Subject: NEPA and NHPA Clearance: 2015-002 Yosemite Lodge Generator Replacement (56597)

Categorical Exclusion Form

Project: 2015-002 Yosemite Lodge Generator Replacement

**Proposed Location for new
Yosemite Lodge Generator**

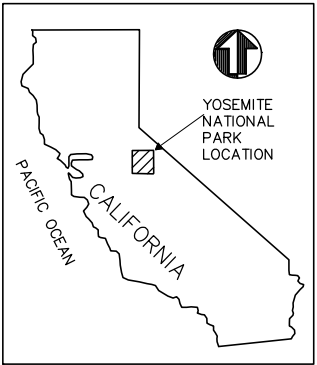
Recommendations for conditions or stipulations: Recommend screening generator from employee housing, with a design compatible with the Lodge to further minimize the visual impact. It could be similar to the fence around the condenser it will be next to.

- **Assessment of Effect - Recommend screening generator from employee housing, with a design compatible with the Yosemite Lodge to further minimize the visual impact. The screen could be similar to the condenser fence.**
